Subject: Byron Generating Station Units 1 and 2
Braidwood Generating Station Units 1 and 2
Reactor Vessel Temperature Limits
NRC Docket Nos. 50-454/455 and 50-456/457

This is to provide revised temperature limits for the Byron and Braidwood reactor vessels. These revisions were made necessitated by the May 27, 1983 amendment of Appendix G to 10CFR50.

FIGURE 3.4-3a

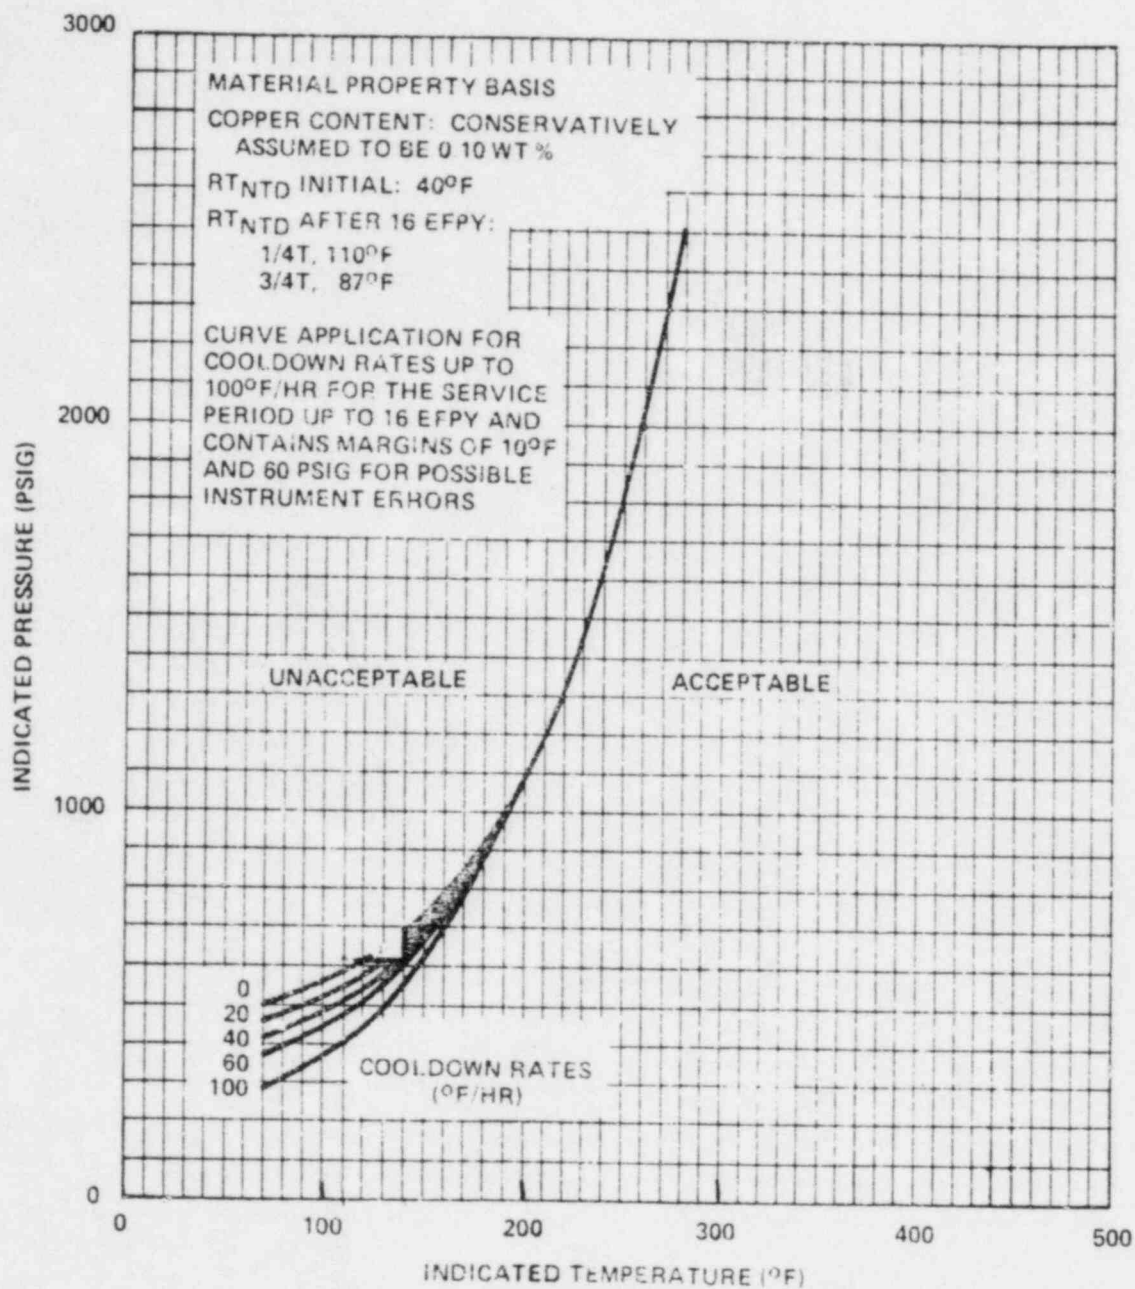
The heatup and cooldown temperature limit curves for all of the Byron/Braidwood reactor vessels have been reviewed against the amended Appendix G requirements. Only the cooldown curves for Byron 1 and Braidwood 2 must be changed to incorporate the new closure flange limitations. Revised copies of those curves (FSAR figures 3.4-3a and 3.4-5b) are enclosed with this letter. Also enclosed is Table I, showing the data used in this review.
